Access Compliance Report

Public Rights-of-Way

(Curb Ramps)

Intersection ID: N/A	Main Street: E MARTIN LUTHER KING JR BLVD	Cross Street: S CALDWELL ST	Location: NE
ADA ID: 629FF746FE9F	Ramp Type: Para	Initial Pass/Fail: Fail	Overall Compliance: No
Codes/Mitigation Info/Possible Solution		Field Measurements/Component Compliance	
Severity Score: 26.25

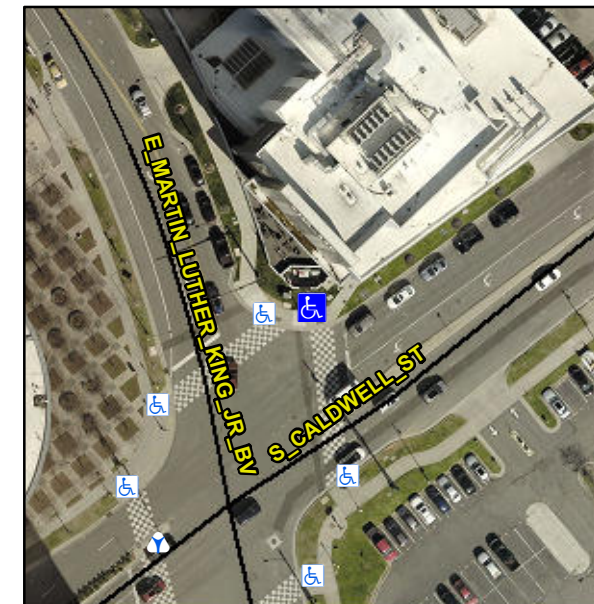
R304.3.2, R304.5.3

Compliance	Description	Data	Compliance	Description	Data
N/A	Ramp Length LT (in)	67.0	N/A	Ramp Length RT (in)	63.0
Yes	Ramp Width LT (in)	96.0	Yes	Ramp Width RT (in)	95.0
No	Ramp Slope LT (%)	12.1	Yes	Ramp Slope RT (%)	5.4
No	Ramp XSlope LT (%)	3.2	No	Ramp XSlope RT (%)	3.6
N/A	Landing Length (in)	N/A	N/A	DWS Provided?	N/A
N/A	Landing Width (in)	N/A	N/A	DWS Contrast?	N/A
N/A	Landing Slope (%)	N/A	N/A	DWS Length (in)	N/A
N/A	Landing X Slope (%)	N/A	N/A	DWS Full Width?	N/A
N/A	Landing Curb? (Y/N)	N/A	N/A	DWS Offset (in)	N/A
N/A	Shared Landing?	N/A			
N/A	Gutter Ponding?	N/A	N/A	Gutter Slope (%)	N/A
N/A	Gutter Lip Ht (in)	N/A	N/A	Gutter X Slope (%)	N/A
N/A	Painted X Walk1?	Yes	N/A	Painted X Walk2?	N/A
	X Walk 1 Direction	To S		X Walk 2 Direction	N/A
N/A	X Walk 1 Width (in)	144.0	N/A	X Walk 2 Width (in)	N/A
	X Walk 1 Slope (%)	0.2		X Walk 2 Slope (%)	N/A
	X Walk 1 X Slope (%)	2.6		X Walk 2 X Slope (%)	N/A
N/A	Ramp inside XWalk1?	Yes	N/A	Ramp inside XWalk2?	N/A

Remove & Replace Entire Ramp.
